ADDENDUM

Date Issued:	February 18, 2022
Project:	Intermountain Healthcare Linear Accelerator Replacement at LDS Hospital 8 th Avenue, C Street Salt Lake City, Utah 84143
Addendum Number:	1

**Intermountain Healthcare
Linear Accelerator Replacement at
LDS Hospital**

NJRA Project # 21226.00
 Construction Documents Jan 31, 2022
 2 Addendum #1 02/18/2022

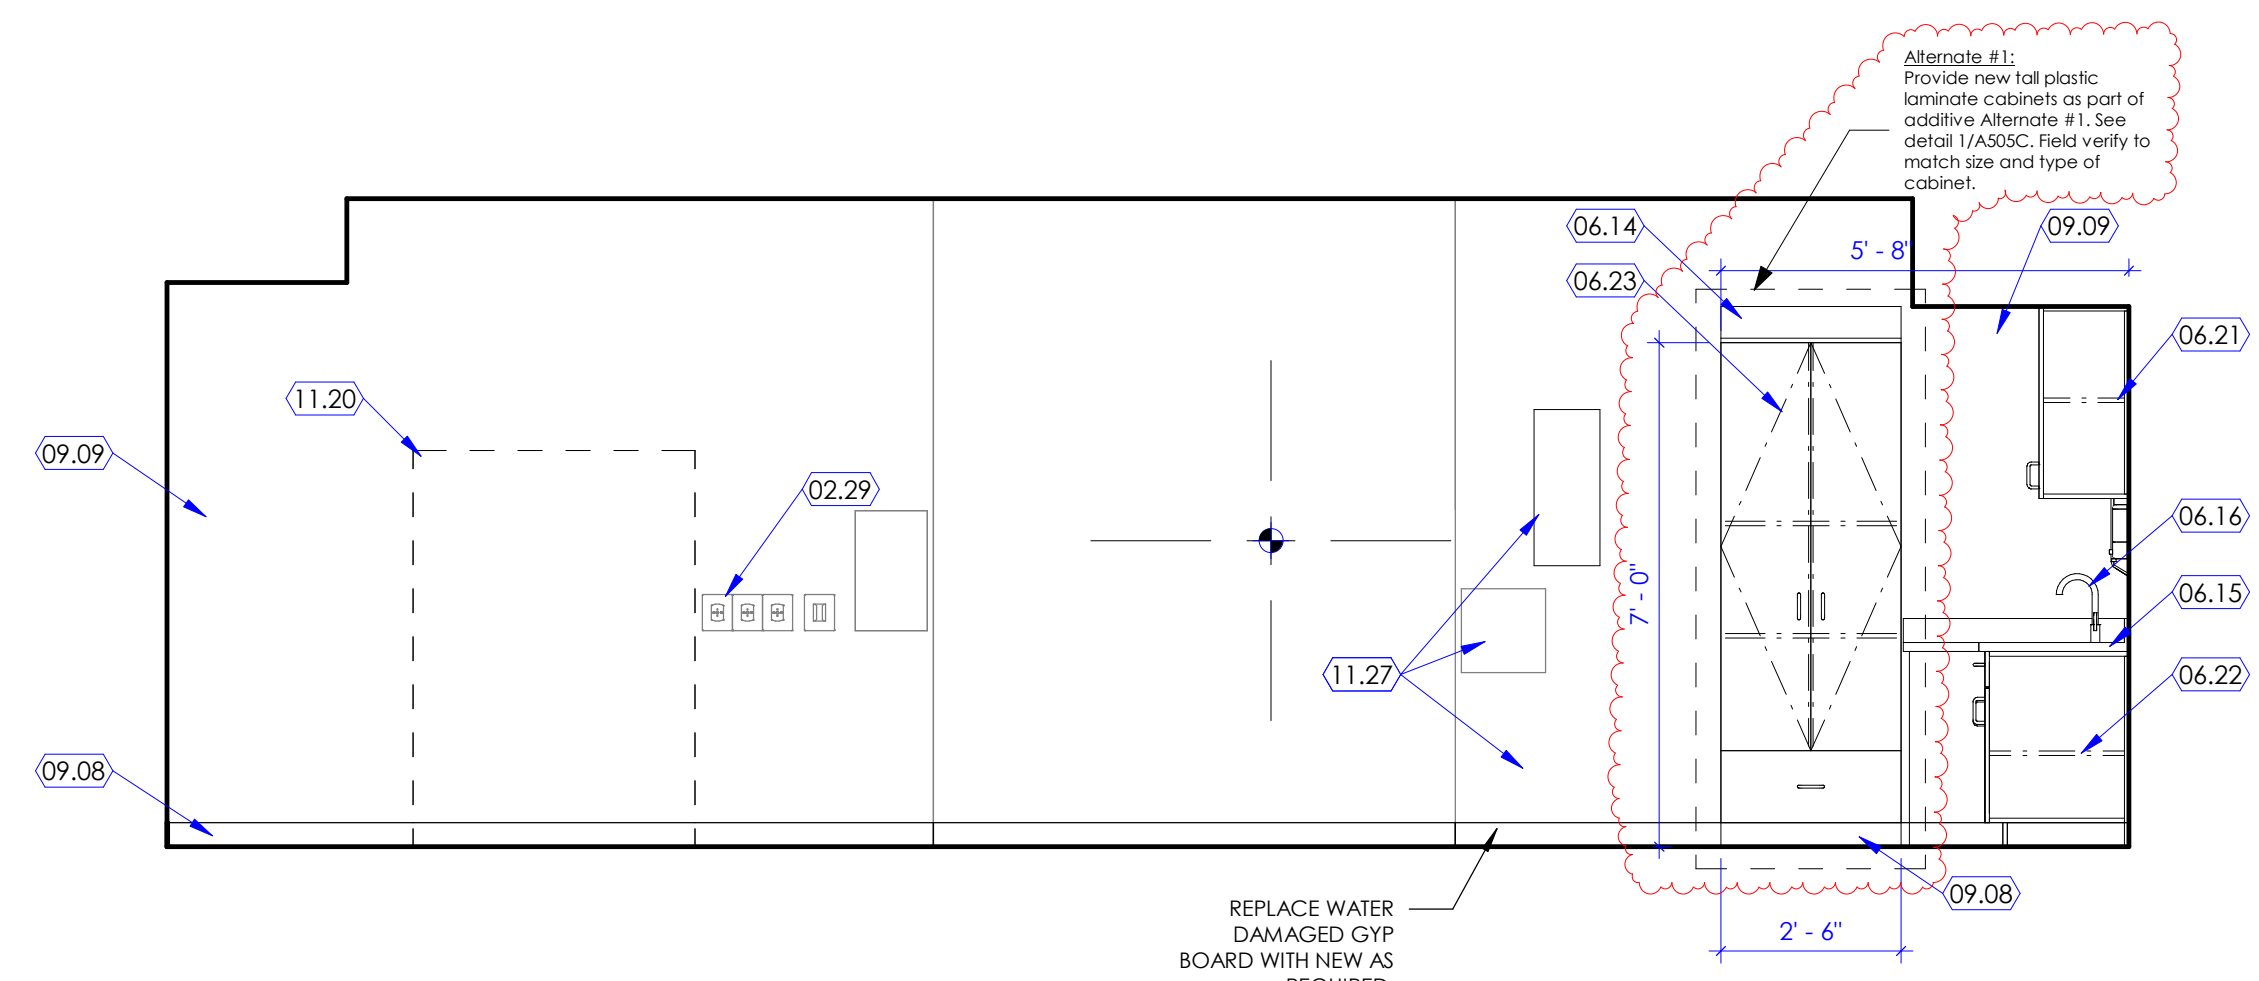
Sheet Number	Drawings
A251	See attached sheet with revision shown clouded.
